UNITED STATES PATENT AND TRADEMARK OFFICE

APPLICATION NO.	FILING DATE	FIRST NAMED INVENTOR	ATTORNEY DOCKET NO.	CONFIRMATION NO.
10/764,121	01/26/2004	Joseph Larsen JR.		7872

Office Action Summary	Application No.		Applicant(s)	
	10/764,121		LARSEN, JOSEPH	
	Examiner		Art Unit	
	Timothy M. Ayres		3637

DETAILED ACTION

Dopp '678 Figures 11 and 12

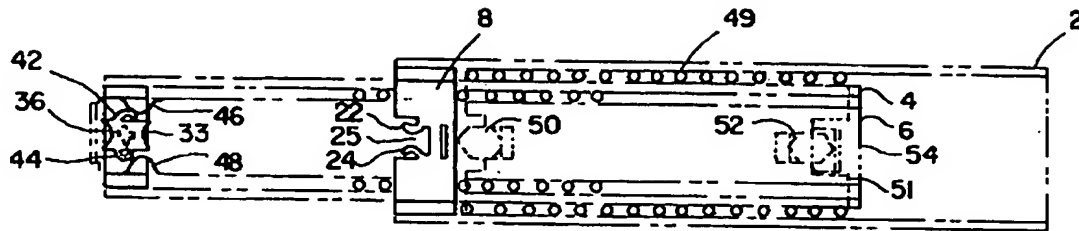
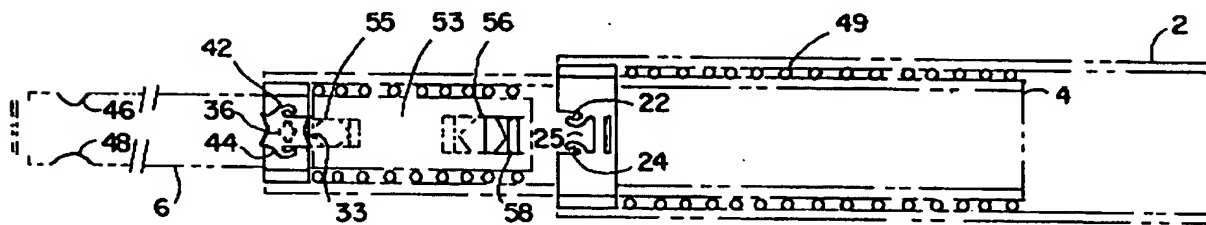
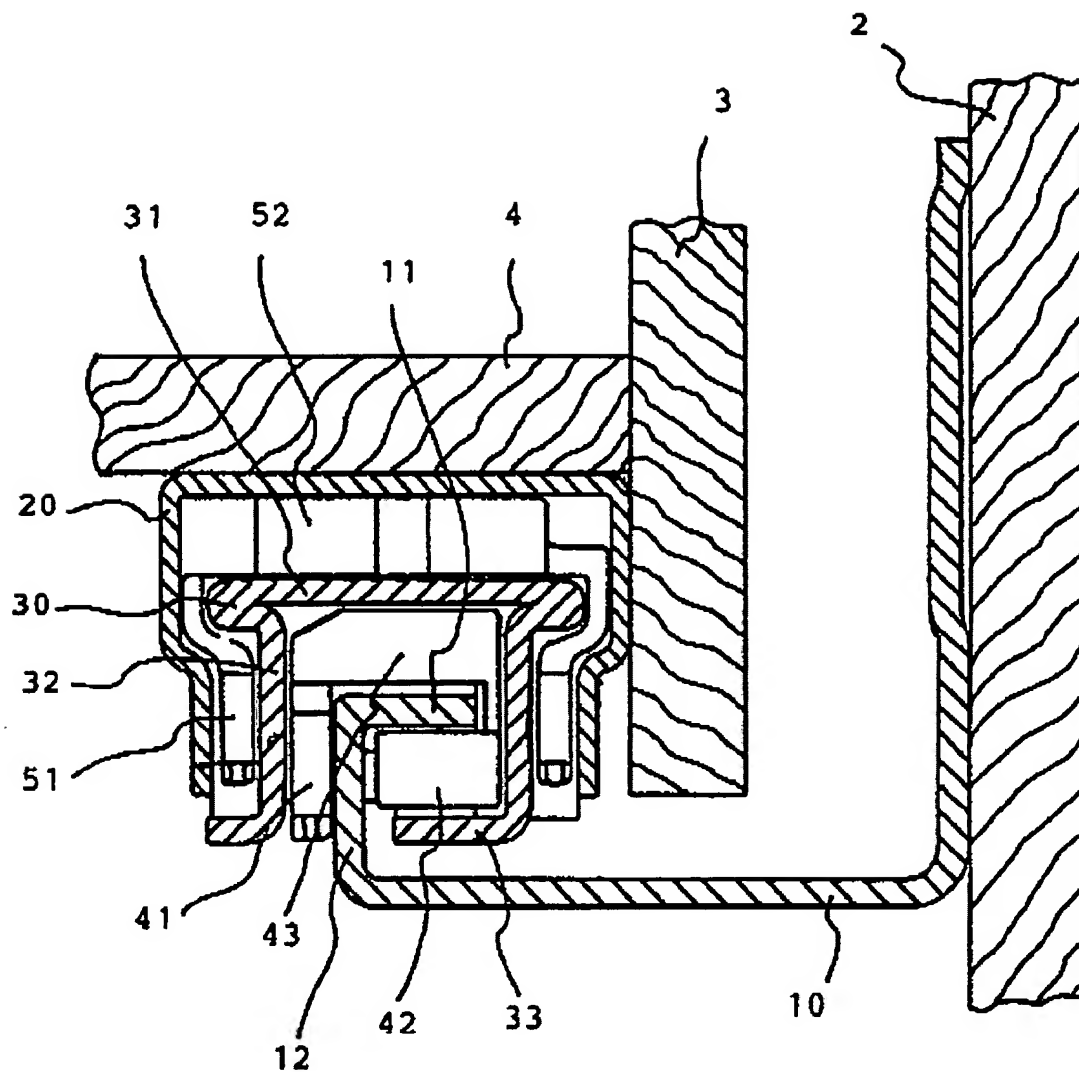
Dopp teaches a guide assembly comprising a supporting rail (2) mounted to a furniture sidewall and a pull out rail (6) secured to the drawer. An intermediate rail (4) is mounted between the supporting rail (2) and the pull out rail (6). A third carriage (51) positioned between the supporting rail (2) and the intermediate rail (4). A first carriage (53) provided between the intermediate rail (4) and the pull out rail (6). The supporting rail (2) and the intermediate rail (4) having at least one stop (33,40,8,12) for limiting the movement of the pull out rail (6), the intermediate rail (4), and the first carriage (51) with respect to the supporting rail (6). The first and third carriages (51,53) have three walls and form a U-shaped member as best understood by the figures. Two of the walls have roller cages located on them with rollers in the cages as best seen in figures 11 and 12. One of the walls has a bumper (50, 52) at the forward edge that project forward and has a bumper (55,56) at the rearward edge that project rearward.

respect to the supporting rail (6). The first and third carriages (51,53) have three walls and form a U-shaped member as best understood by the figures. Two of the walls have roller cages located on them with rollers in the cages as best seen in figures 11 and 12. One of the walls has a bumper (50, 52) at the forward edge that project forward and has a bumper (55,56) at the rearward edge that project rearward. At the time of the invention it would have been obvious for a person of ordinary skill in the art to modify the guide rail of Kung by adding a forwardly projecting bumper, a rearwardly projecting bumper, and stops as taught by Dopp to help prevent the drawer from rebounding when closed or opened.
